SAN FRANCISCO PLANNING DEPARTMENT

MEMO

RE: Review and Comment for the proposed alterations to 865 Market Street (Category V – Unrated Building located within the Article 11 Kearny-Market-Mason-Sutter Conservation District)
Case No. 2018-007267CUA/OFA/PTA

FACADE CONCEPT UPPER REGISTER SECTION

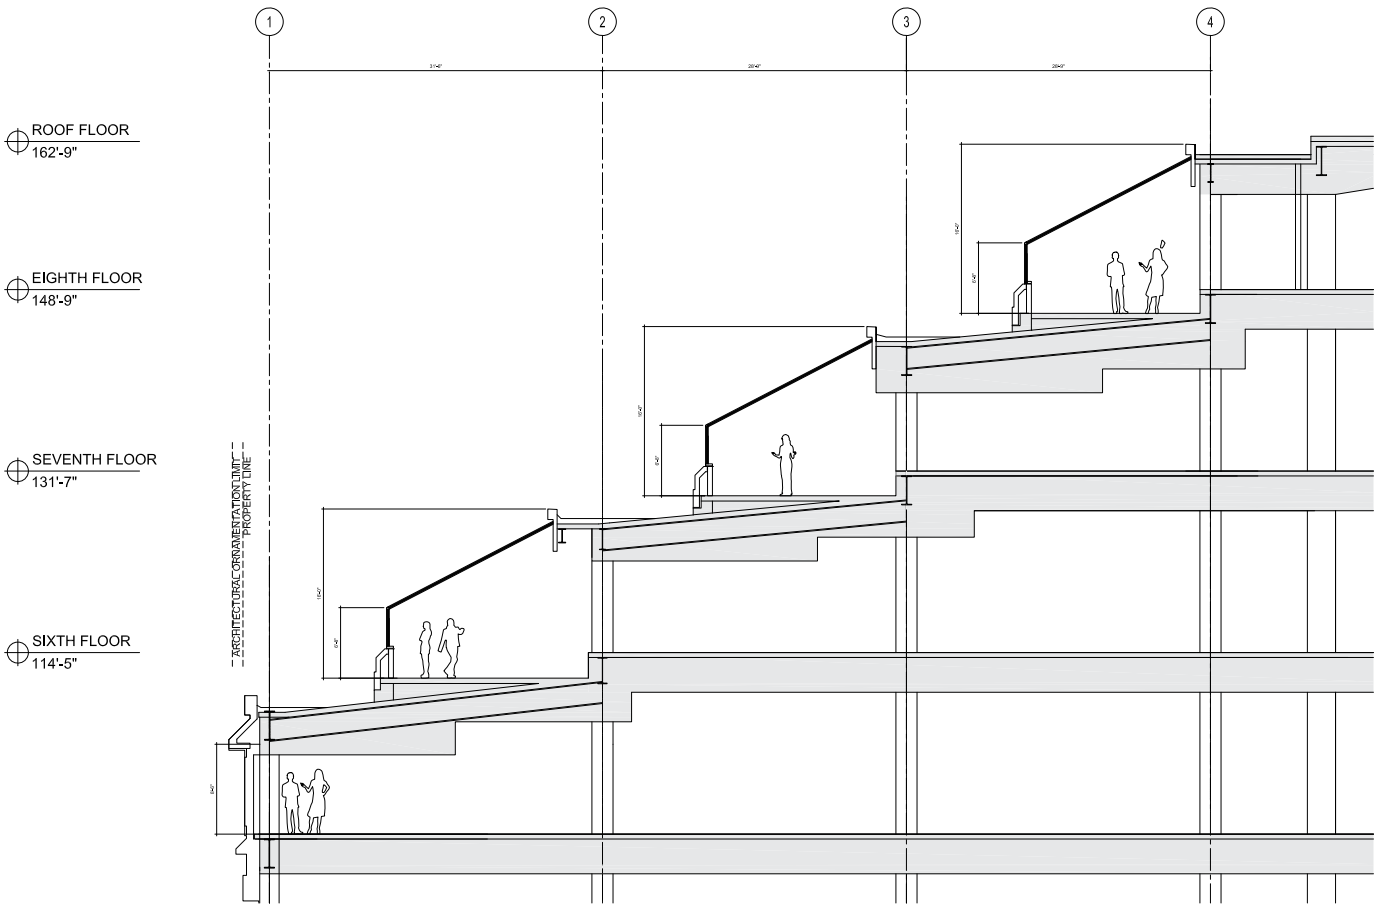
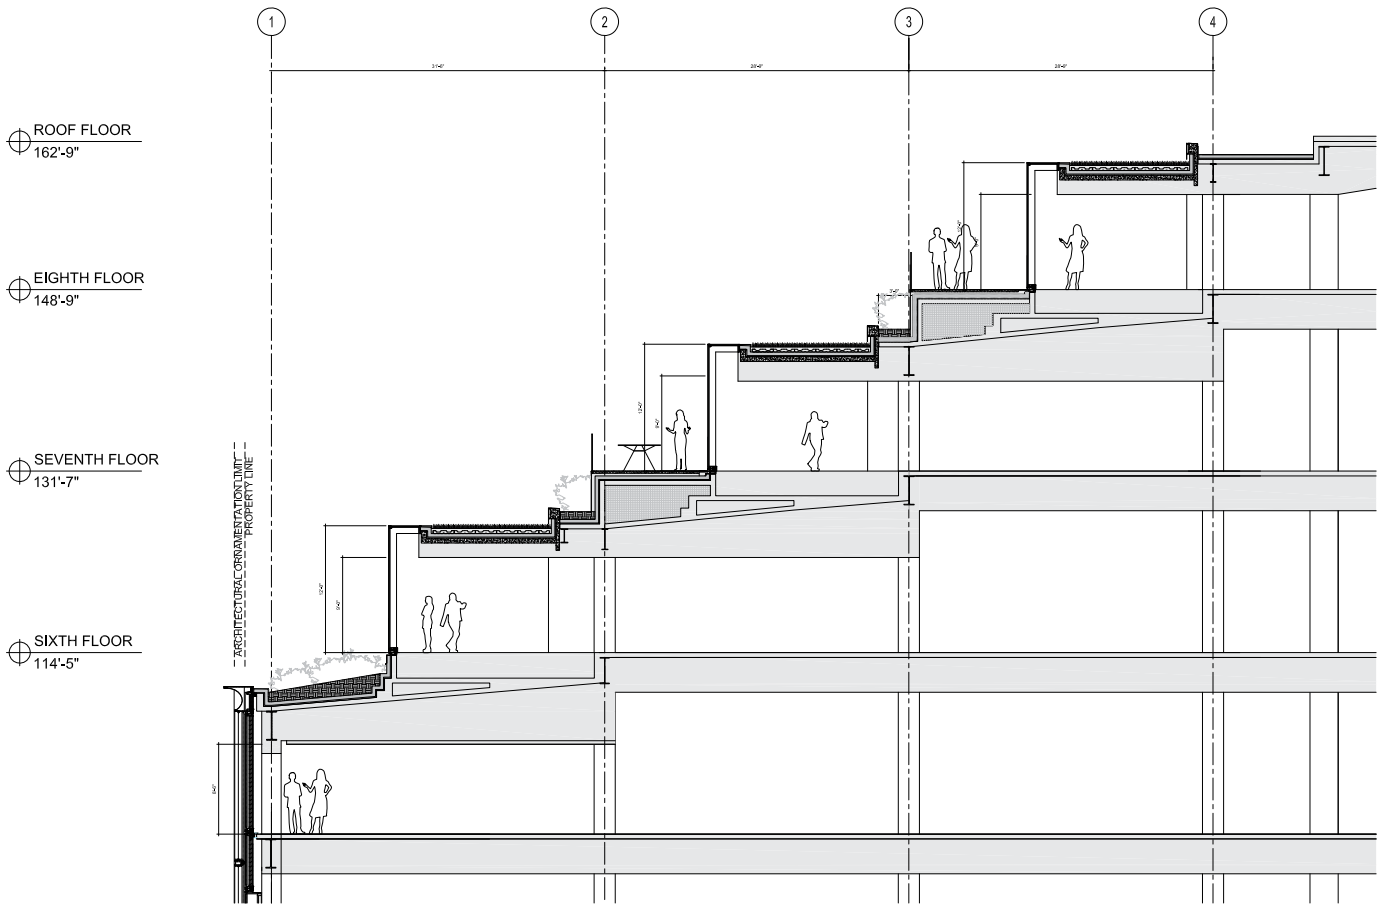
Recommendation: Staff recommends further study regarding the depth and profile of the belt course, cornice, and screen wall fins. While the renderings and sections currently provided do partially address this, Department staff believes additional investigation would be helpful to understand the relation of proposed alterations to the existing building face, as well as the sense of visual depth the fins may create through light and shadow. Further study could also address questions related to maintenance.

WESTFIELD SAN FRANCISCO CENTRE
KMMS SECTION 7
CONFORMITY RESPONSE

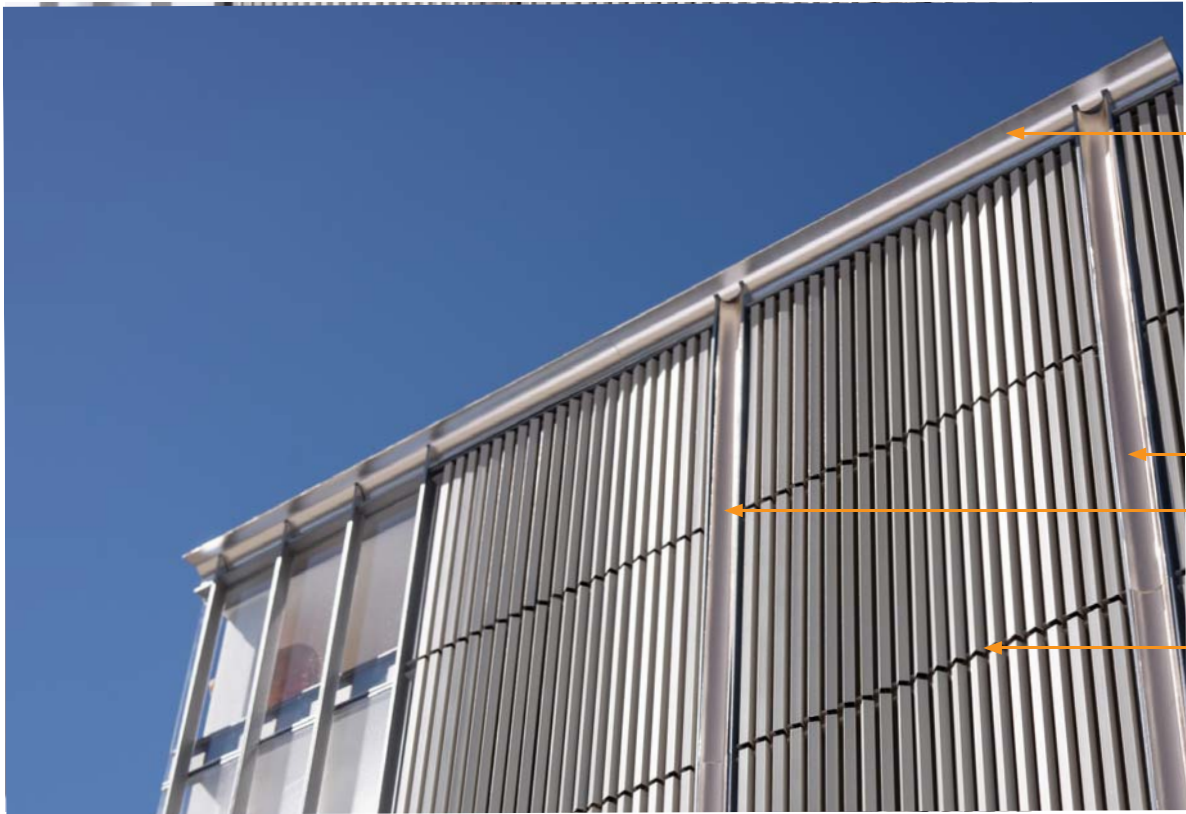
UDAT Comment:

A prominent projecting horizontal cornice has been added to reinforce the roof line and alignment with 901 Market Street.

Horizontal divisions of the screen wall are meant to emphasize the floor lines and fenestration proportions typical of the existing building and the district.

Historic Preservation: Kearny-Market-Mason-Sutter Conservation District (Planning Code Article 11, Appendix E, Section 7: Standards and Guidelines for Review of New Construction and Certain Alterations.

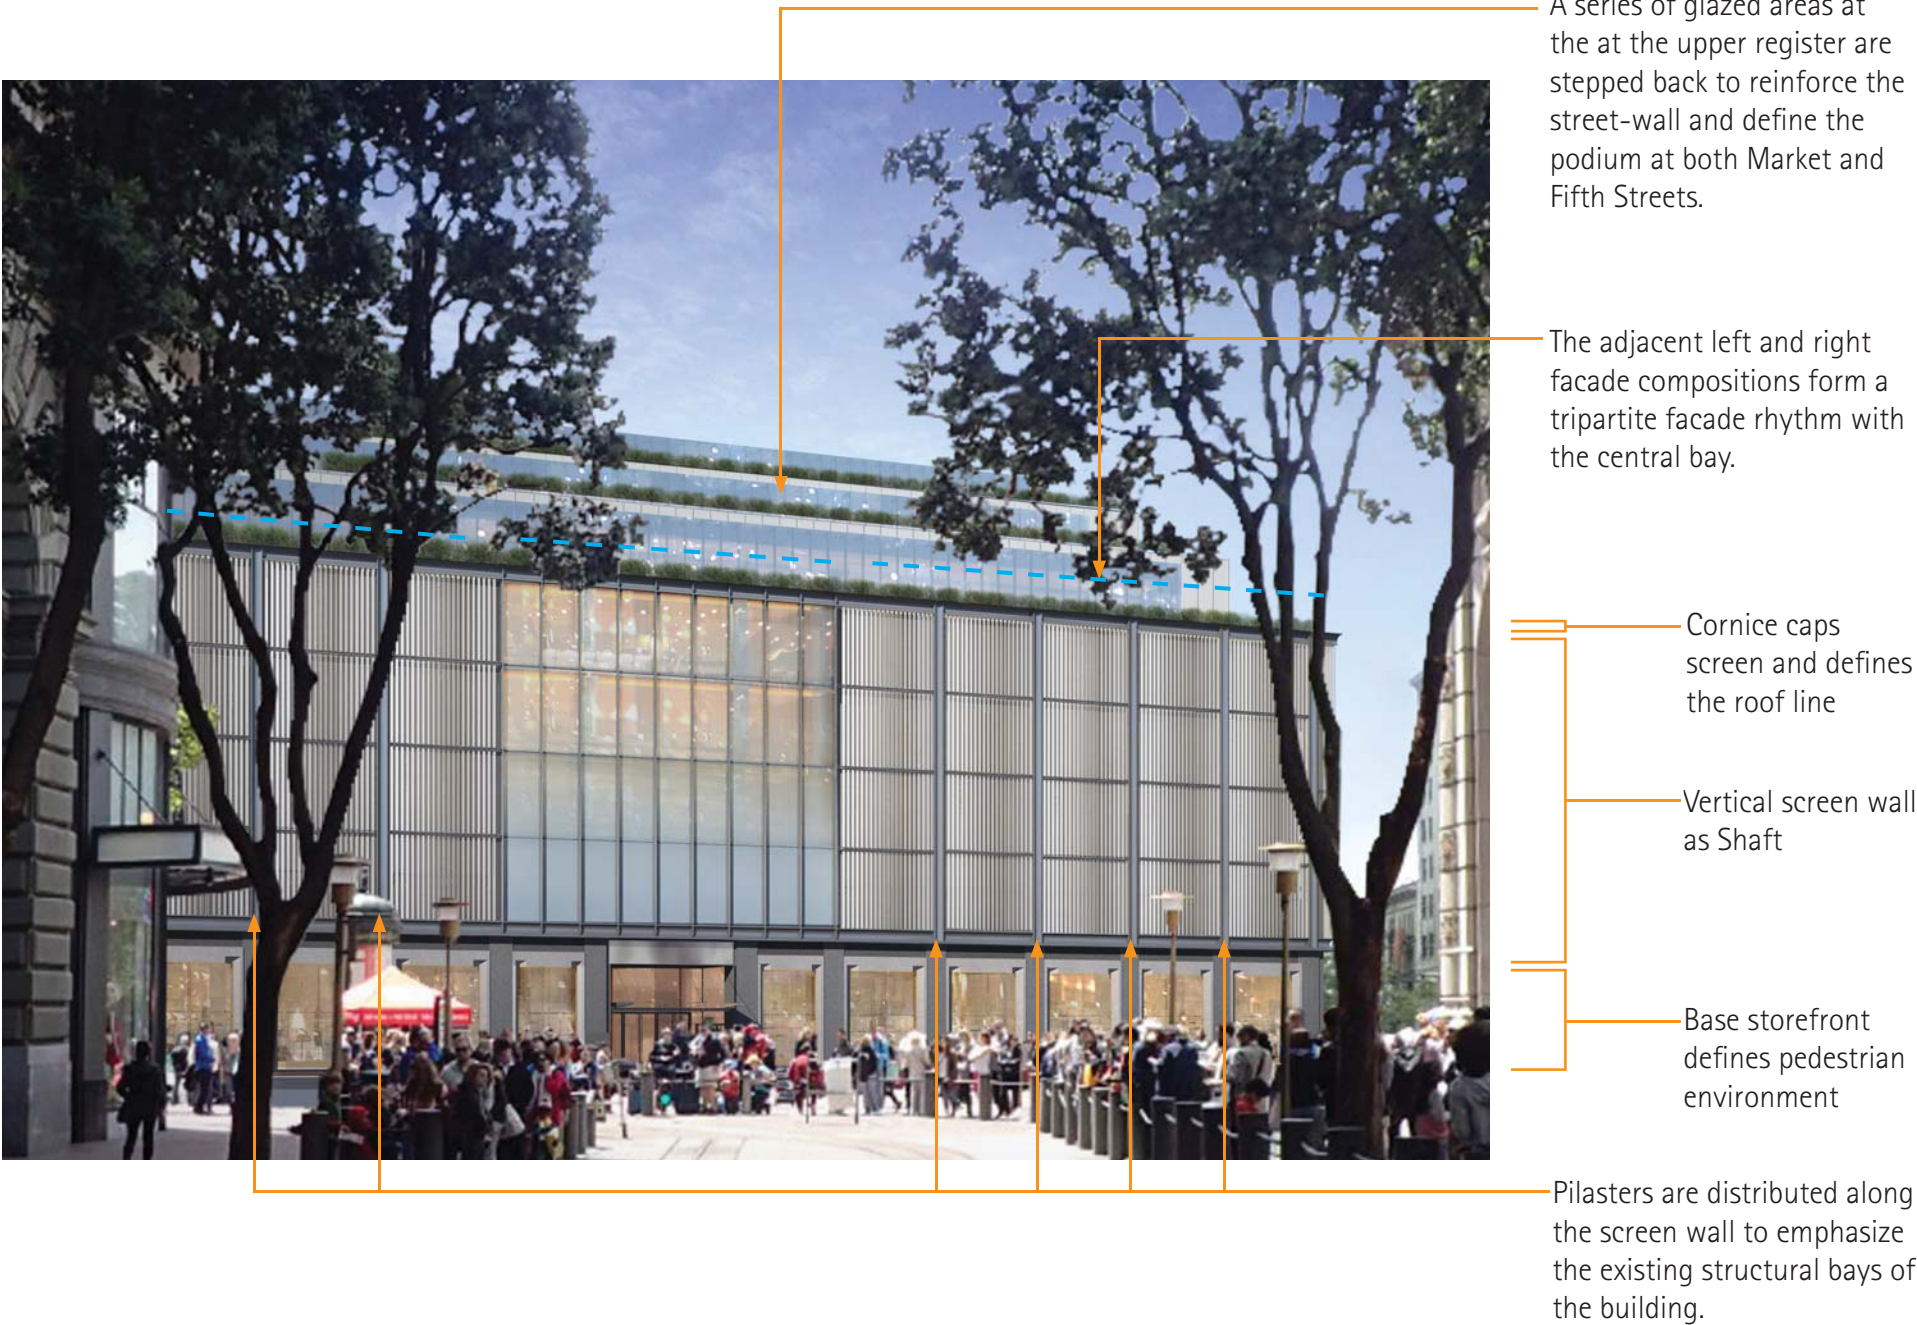
UDAT Comment:

Design Response:

Historic Preservation: Kearny-Market-Mason-Sutter Conservation District (Planning Code Article 11, Appendix E, Section 7: Standards and Guidelines for Review of New Construction and Certain Alterations.

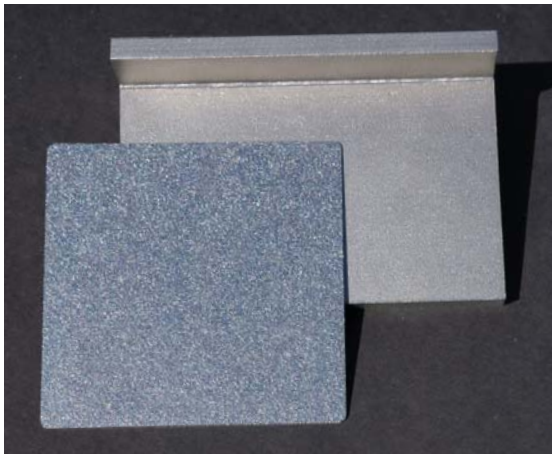
UDAT Comment:

The fenestration/glazing imparts hierarchy and order to the facade composition, and creates a visual link between the vibrant retail environment within the San Francisco Centre and the street environment. The wide central glazing is made proportionally compatible with the district by the use of vertical stainless steel fin subdivisions that align with the existing bays and reflect the fenestration scale representative of the district.

The fenestration/glazing imparts hierarchy and order to the facade composition

The wide central glazing is made proportionally compatible with the district by the use of vertical stainless steel fin subdivisions that align with the existing bays and reflect the fenestration scale representative of the district.

Historic Preservation: Kearny-Market-Mason-Sutter Conservation District (Planning Code Article 11, Appendix E, Section 7: Standards and Guidelines for Review of New Construction and Certain Alterations.

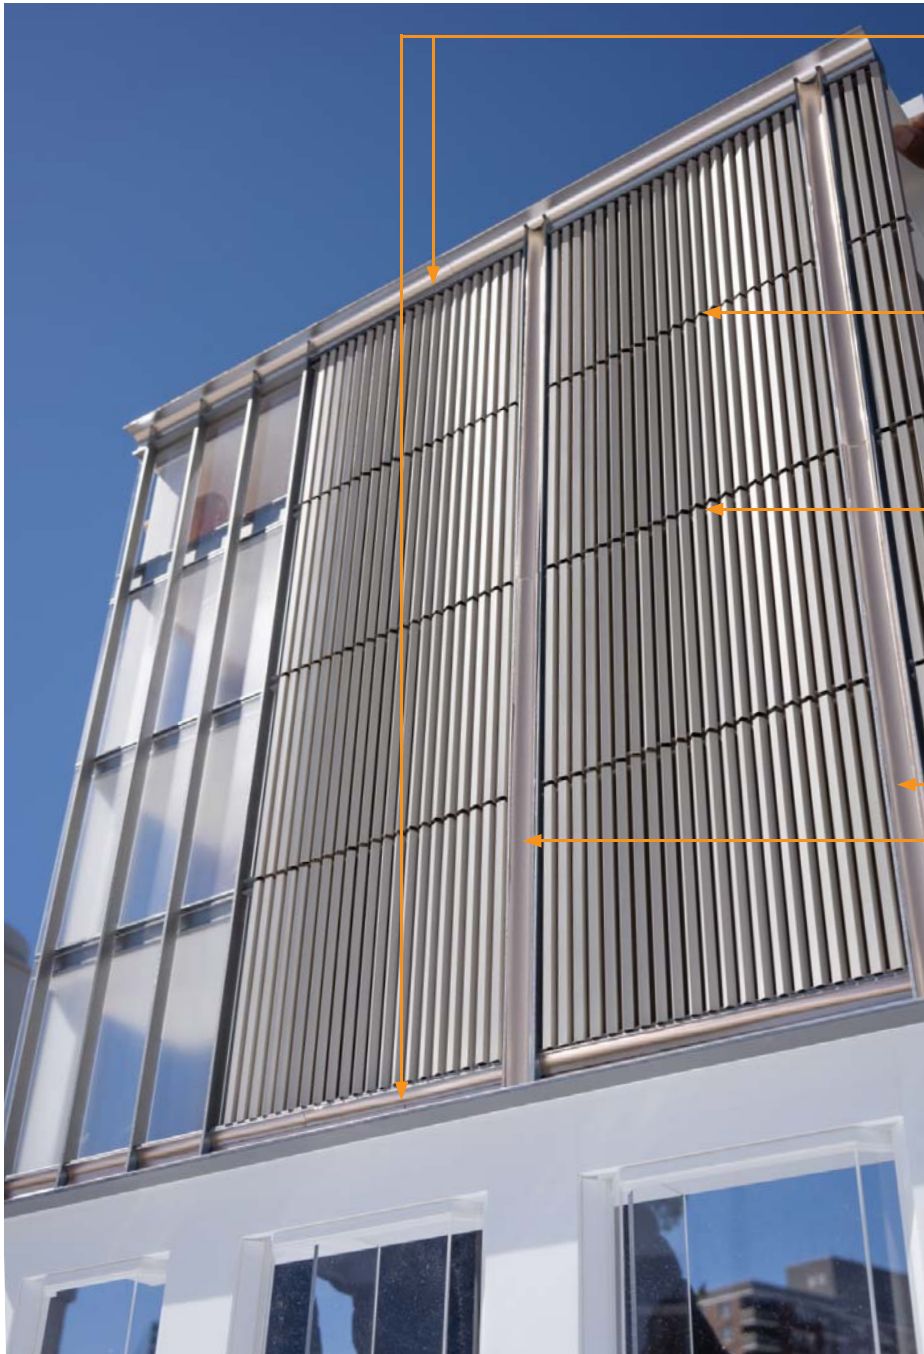
UDAT Comment:

Provide additional detail on the proposed material and color palette. Consider alternative screening materials that could compliment neighboring Significant and Contributory Buildings better than the proposed Anodic-Coated Aluminum Screen Wall System.

The finish of the vertical members of the screen wall has been revised to a warm off-white semi-gloss finish, meant to echo the color and finish of glazed terra cotta found on the adjacent Emporium building and predominantly seen in the district. The cornice, belt course and pilasters provide definition to the screen wall through a stainless steel materiality in a mixture of bead-blasted and satin textured Sandstone finish. This is meant to articulate a contemporary take on the Beaux-Arts cornice and pilaster.

A prominent projecting flaring cornice and belt course have been added at the head and base of the screen wall
